Item Name: Floor Provisions

DART SERVICE INSTRUCTION

TO AMEND INSTALLATION INSTRUCTIONS IIN-D350-689 REV. B AND INSTRUCTIONS FOR CONTINUED AIRWORTHINESS ICA-D350-689 REV. 1

REF. TCCA STC: SH02-33
REF. FAA STC: SR01620NY
REF. EASA STC: EASA.IM.R.S.01453
REF. TCA STC: 2005S03-09

FIGURE 1: UPDATES TO CROSS SECTIONS F-F AND M-M
 With reference to Figures 5 and 7 of IIN-D350-689
 (Figures 25-5 and 25-7 of ICA-D350-689)

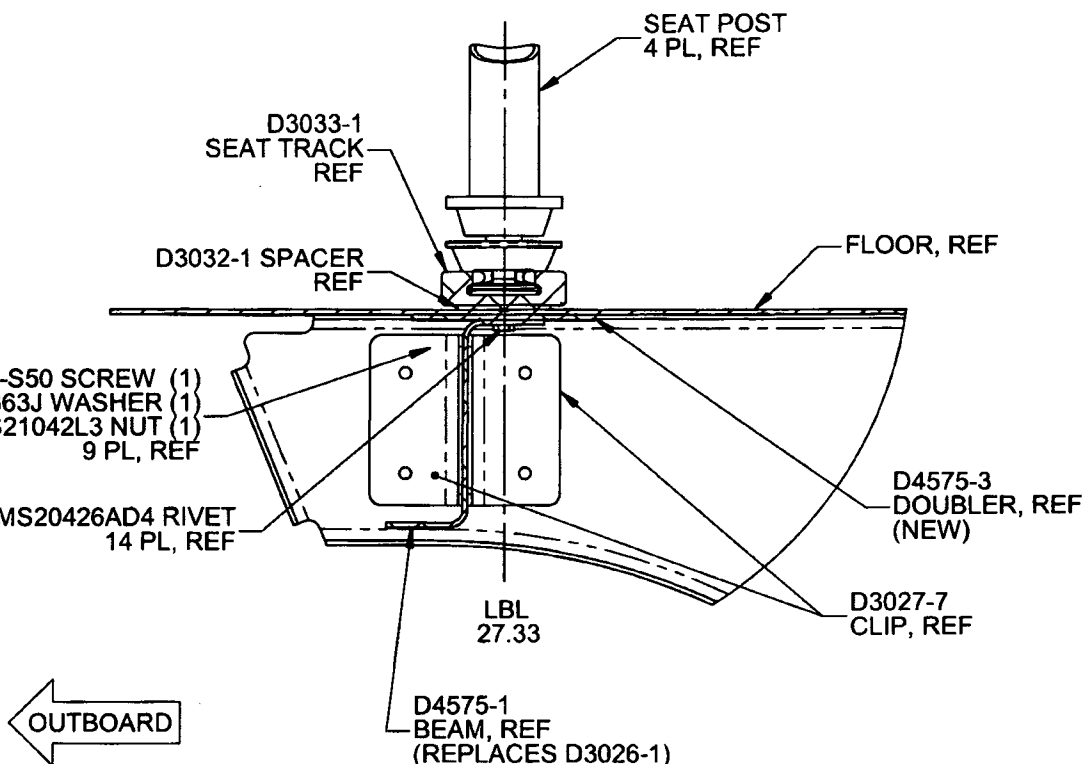
If there is an existing stringer at LBL 27.33, it will need to be removed from that location. Locate D4575-1 Beam, D4575-3 Doubler, and D3032-1 Spacer as shown in Figure 1 of this Service Instruction. Transfer drill existing holes from the aircraft floor to the D4575-1 Beam, D4575-3 Doubler, and D3032-1 Spacer. Ensure 1.0" to 1.5" rivet pitch and add additional holes if required. If there is no existing stringer, locate D4575-1 Beam, D4575-3 Doubler, and D3032-1 Spacer as shown in Figure 1 of this Service Instruction and drill Ø0.128" holes on a 1.0" to 1.5" pitch.

Counter sink holes in the D3032-1 Spacer for MS20426AD4 rivets. Install D4575-1 Beam, D4575-3 Doubler, and D3032-1 Spacer to floor using MS20426AD4 rivets.

FIGURE 2: UPDATES TO FIGURE 21 (IIN-D350-689) AND 25-21 (ICA-D350-689)

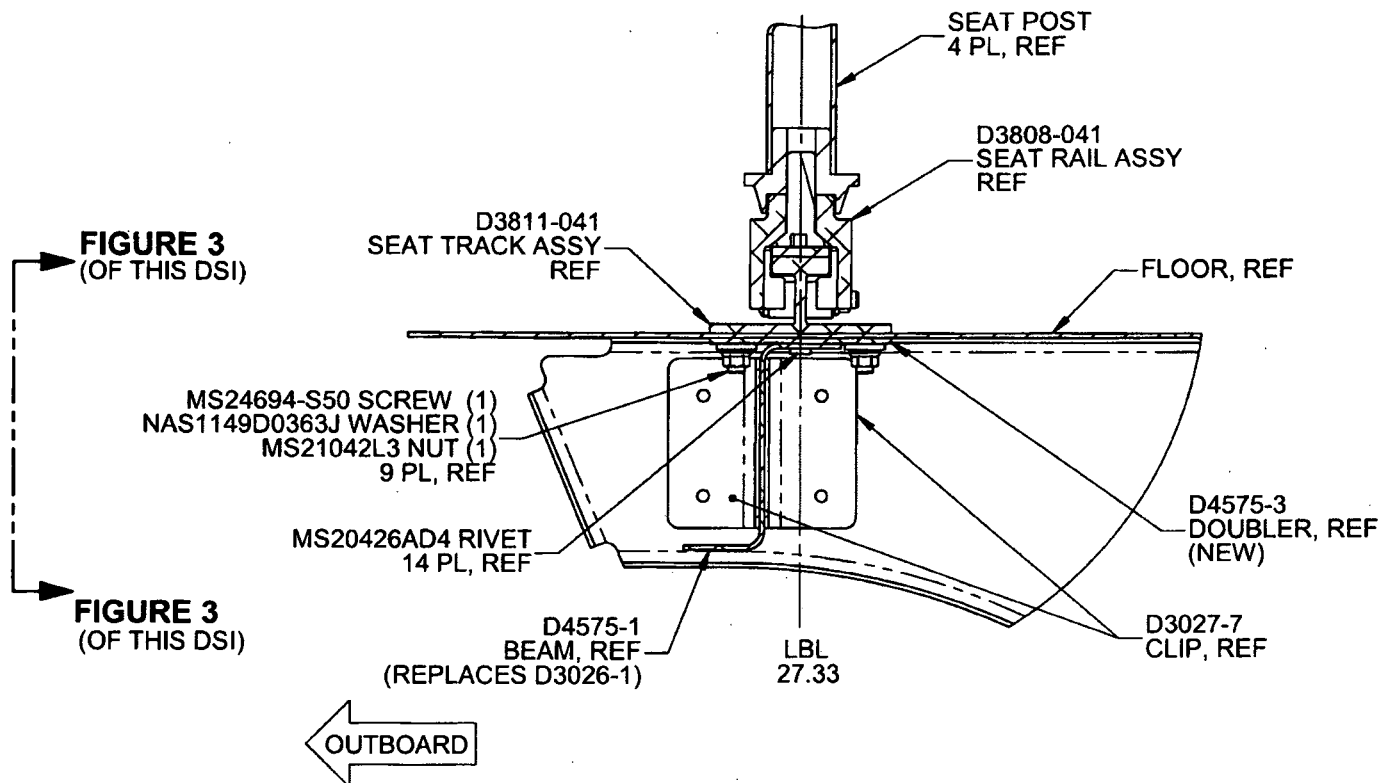
If there is an existing stringer at LBL 27.33, it will need to be removed from that location. Locate D4575-1 Beam and D4575-3 Doubler as shown in Figure 2 of this Service Instruction. Transfer drill existing holes from the aircraft floor to the D4575-1 Beam and D4575-3 Doubler. Ensure 1.0" to 1.5" rivet pitch and add additional holes if required. If there is no existing stringer, locate D4575-1 Beam and D4575-3 Doubler as shown in Figure 1 of this Service Instruction and drill Ø0.128" holes on a 1.0" to 1.5" pitch.

Attach D4575-1 Beam and D4575-3 Doubler to floor using qty (14) MS20426AD4 rivets.

FIGURE 3: RELIEFS ON D4575-1/-3
(ONLY D4575-1/-3 SHOWN FOR CLARITY)
VIEW LOOKING INBOARD

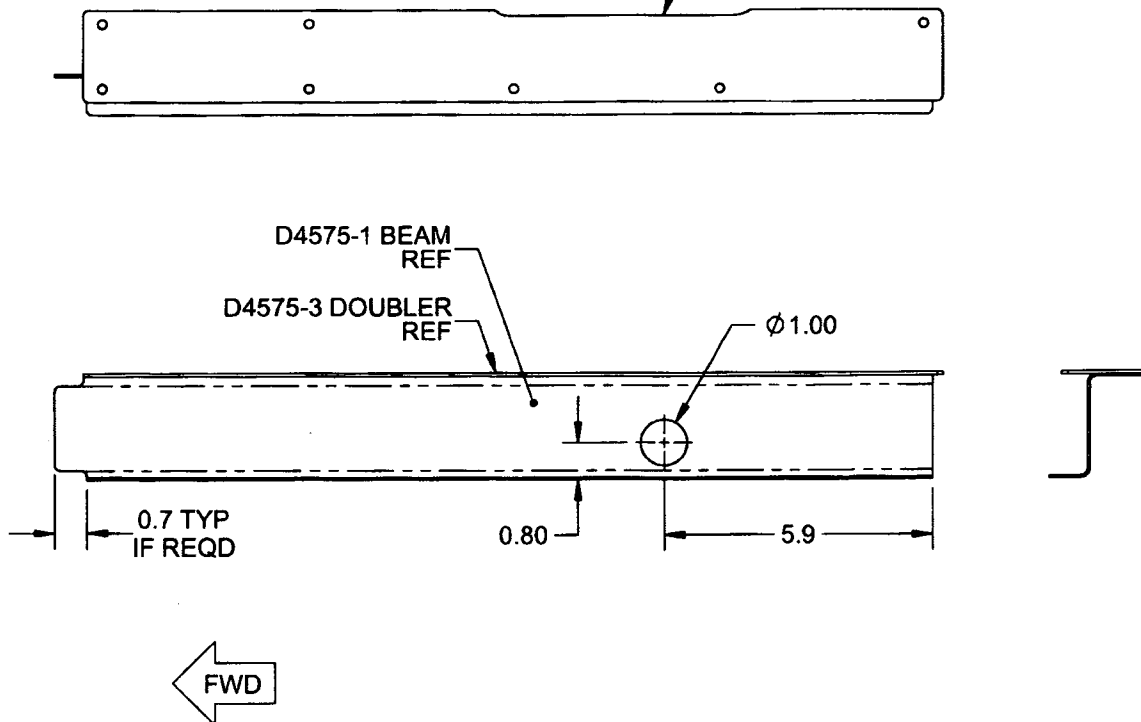
Note: Drill a Ø1.00" (Ø25.4 mm) hole in the D4575-1 Beam to clear extension tube of collective and cutout as required for clearance of collective opening and fwd bulkhead as shown in Figure 3 of this Service Instruction.

Note: Drill a Ø1.00" (Ø25.4 mm) hole in the D4575-1 Beam to clear extension tube of collective and cutout as required for clearance of collective opening and fwd bulkhead as shown in Figure 3 of this Service Instruction.

TRANSFER EXISTING CUTOUT
FROM AIRCRAFT FLOOR A/R TO
D4575-1/-3 FOR COLLECTIVE OPENING
